UNITED STATES  
NUCLEAR REGULATORY COMMISSION  
WASHINGTON, D. C. 20555

Docket No. 50-508

SUBJECT: SUMMARY OF MEETING OF THE STAFF WITH  
WASHINGTON PUBLIC POWER SUPPLY SYSTEM  
CONCERNING GEOSCIENCE ISSUES FOR WNP-3  
(WPPSS LETTER DATED 11/20/87), APRIL 5,  
1988

Figure 230.5-2. Site-Specific Spectra Based on Statistical Analysis of Recorded Spectra Scaled to Magnitude 7.5 and Distance 35 km

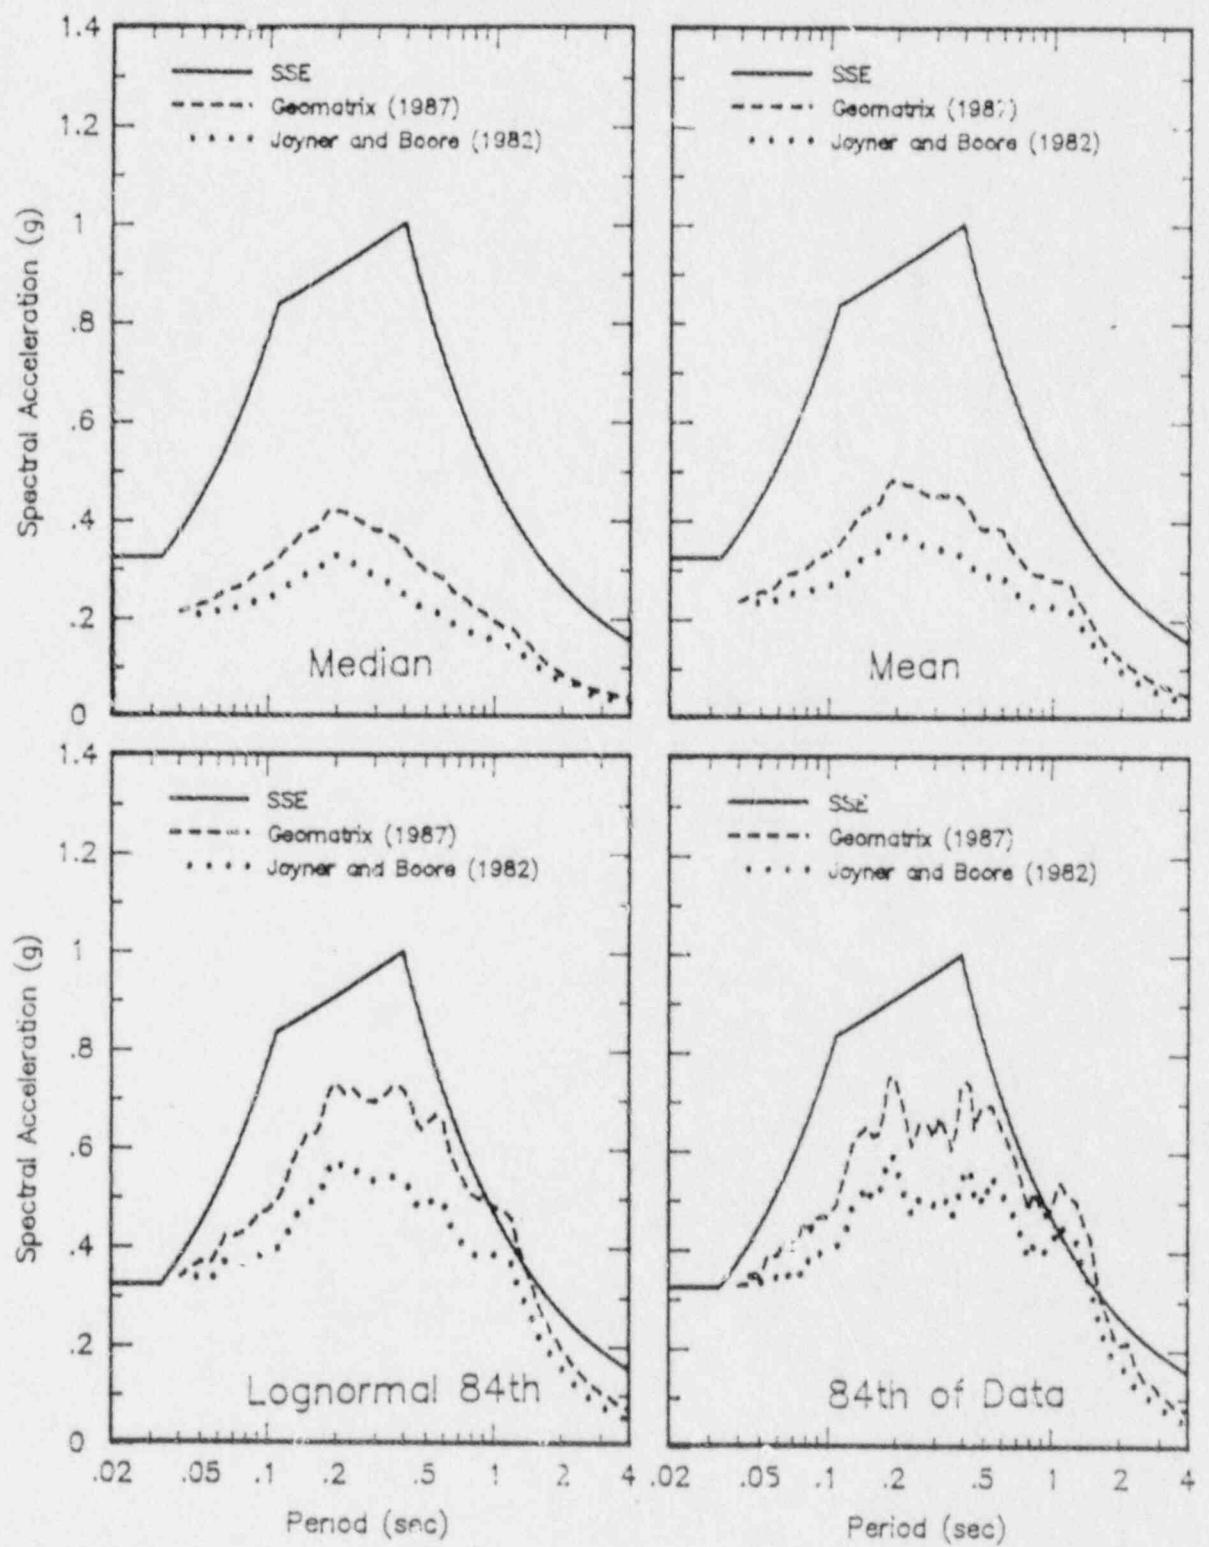
Estimate site-specific spectra for a range of percentiles for the maximum earthquake on the Olympia Lineament, using strong-motion data in the appropriate magnitude and distance range. Justify the SSE spectra in light of the site-specific spectra.

- statistics of recorded motion spectra
- statistics of scaled spectra
- generalized attenuation relationships
